## SERVICE BULLETIN

## 651613-x, 651615-x-D, 651616-x Ram

**BULLETIN:** #1-11

## Air Leakage Out the Control Valve Exhaust on Downstroke

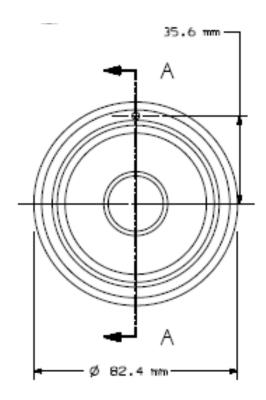
Changes affect models manufactured after 10 August 2011 (S/N H1101-xxx)

Modifications were made to 94123 Back-up to insure that sufficient air pressure is able to actuate the 94005 Piston seal during the down stroke of the ram

A Ø 3 mm hole was added as shown in the illustration below to 94123 Back-up
